QUESTION 110.1

SSES-FSAR

**SUSQUEHANNA STEAM ELECTRIC STATION
UNITS 1 AND 2
FINAL SAFETY ANALYSIS REPORT**

PP&L DRAWING

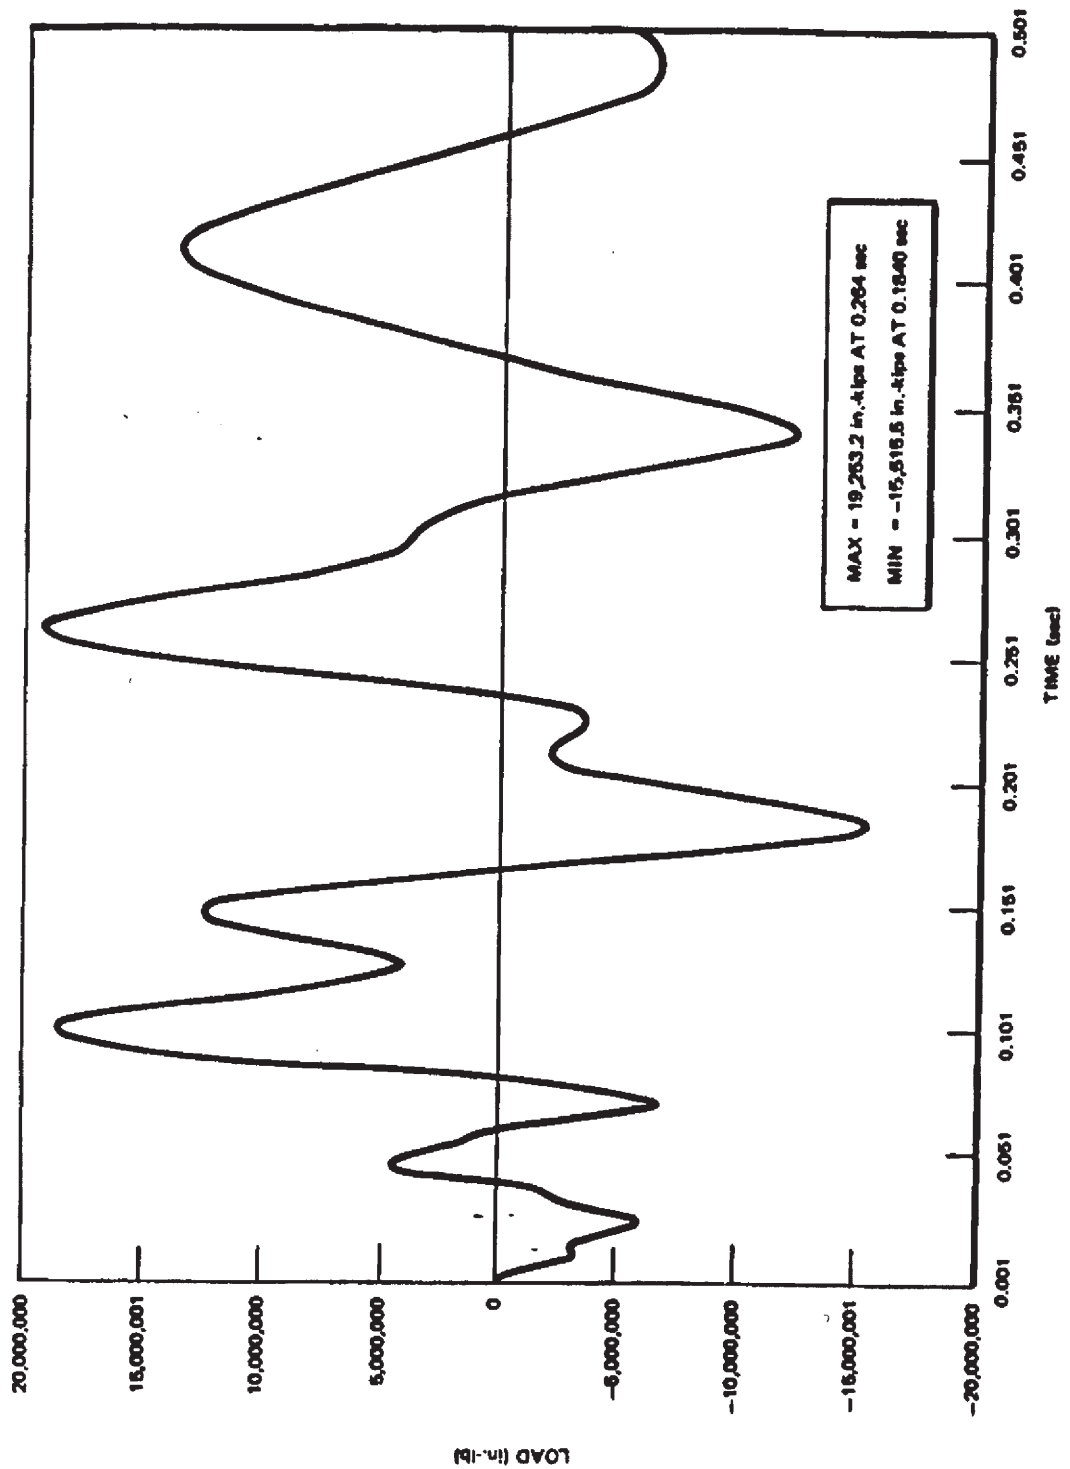
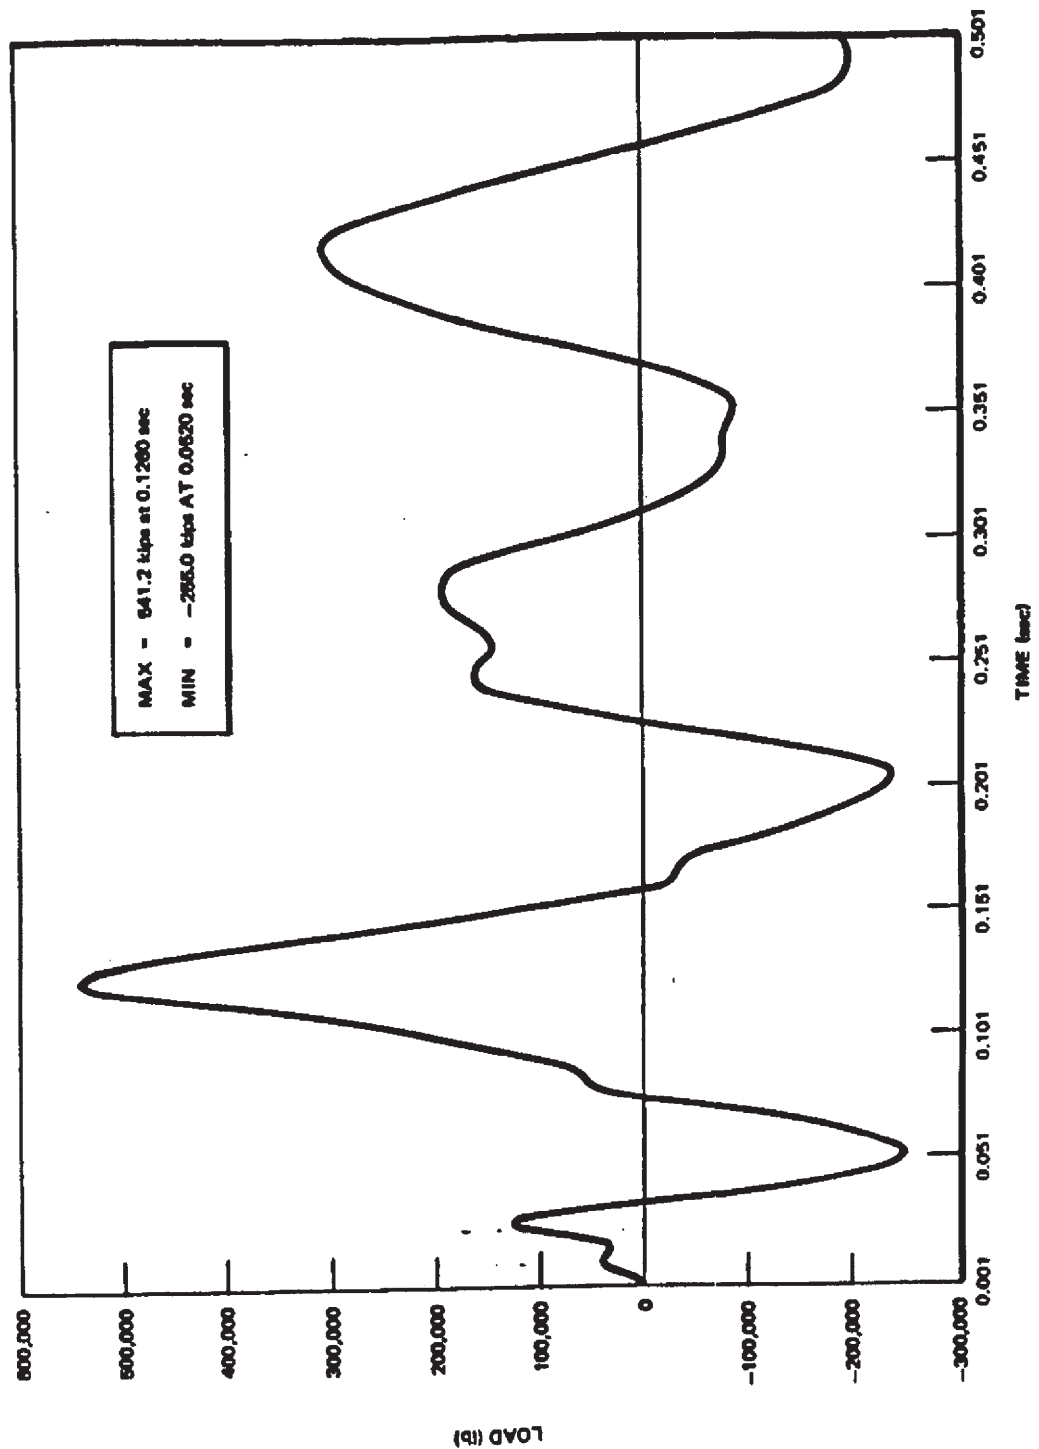
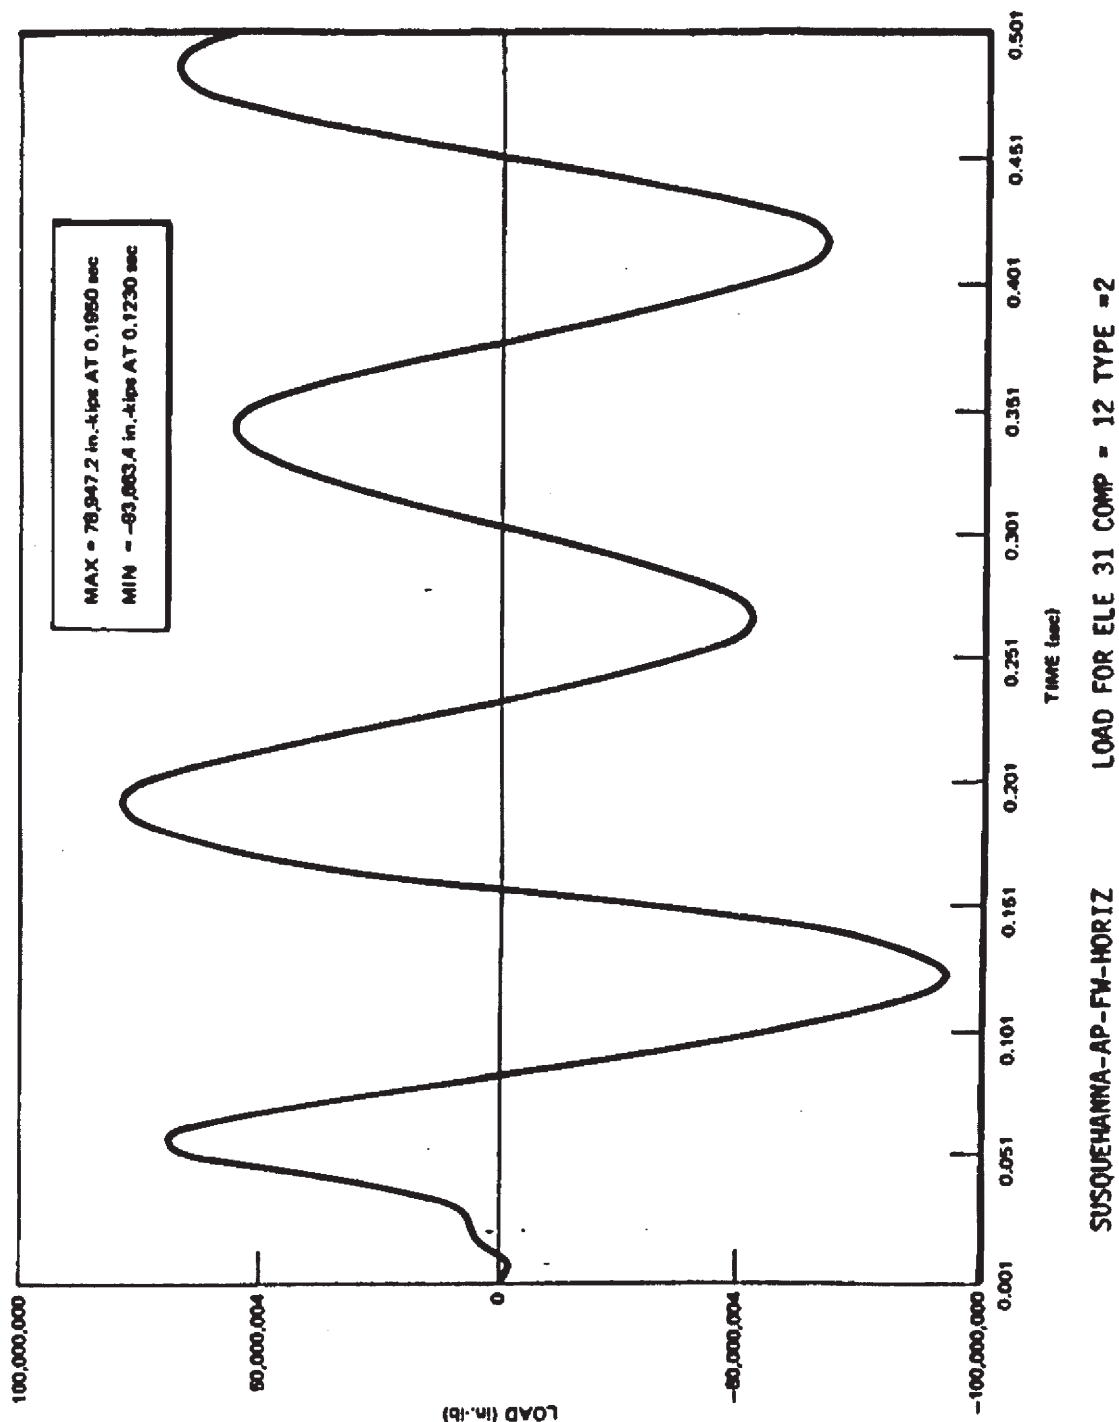
- a) Provide response time histories at one key location (having either the maximum stress combination or the most critical deflection combination, whichever is governing the design) for each of the following internal components:
 - (1) Jet pump
 - (2) Shroud wall
 - (3) Shroud head
 - (4) Control rod
 - (5) Instrumentation guide tube
 - (6) Core plate

For each location, separate response time histories for the various load effects associated with the SSE and most severe pipe break event should be provided.

- a) The following additional response time information for selected internal components under the SSE and the most severe pipe break accidents is provided.

Figures 110.41-3 thru 110.41-10 - Response time history plots due to horizontal SSE.

Figures 110.41-11 thru 110.11-16 - Response time history plots due to vertical SSE.

Figures 110.41-17 thru 110.41-24 - Response time history plots due to recirculation pipe break.

Figures 110.41-25 thru 110.41-32 - Response time history plots due to feedwater pipe break.

As for the pipe break events, we have considered both the feedwater line break and the recirculation line break. Judging from the response time histories, it is not conclusive as to which one is governing. Hence, we have included both sets.
